Amendments to the Drawing Figures:

REMARKS

Fig. 2

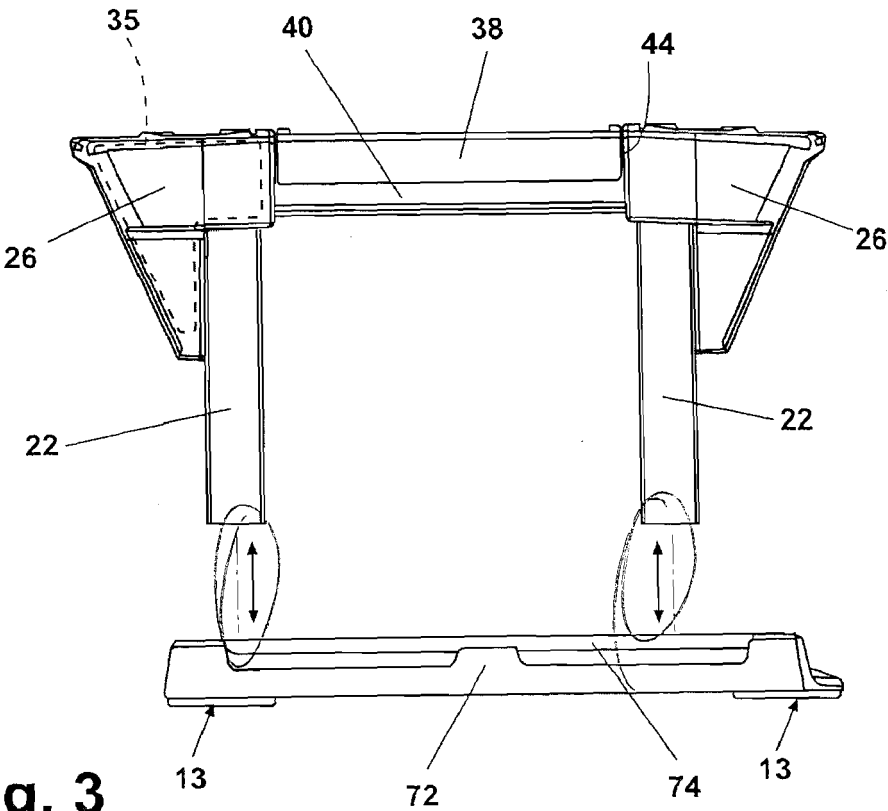
The drawing figures submitted previously have been amended to remove any structure deemed to constitute new subject matter. In particular the lines outlining the recess receiving the upright support members have been removed. A set of drawing figures showing the proposed changes are attached with the proposed change enclosed within the circled regions.

The drawings were objected to because they failed to show that the electrical socket was attached to a power supply of the vehicle, and that the framework assembly could be removed from the base assembly as claimed and described in the patent specification.

The drawings have been amended as illustrated by the annotations accompanying this response. Moreover this issue has also been addressed by amending the claims. In particular the claims citing a power socket or electrical supply have been cancelled or

amended to remove the reference. The drawings have also been amended to reflect the modular nature of the invention consistent with the Examiner's earlier indication this feature, if placed in independent format, would place the application in condition for allowance.

Applicant notes with appreciation that the corrections proposed in the response dated July 5, 2005 have been approved. Additional sheets of drawing containing annotations on the alternate configuration of the framework assembly to the base assembly are attached to this response in accordance with 37 CFR § 1.121(d). In light of the above, applicants respectfully submit the drawing figures are now fully compliant with the requisites of MPEP § 608.02(d) and 37 CFR § 1.83(a). Reconsideration is requested.
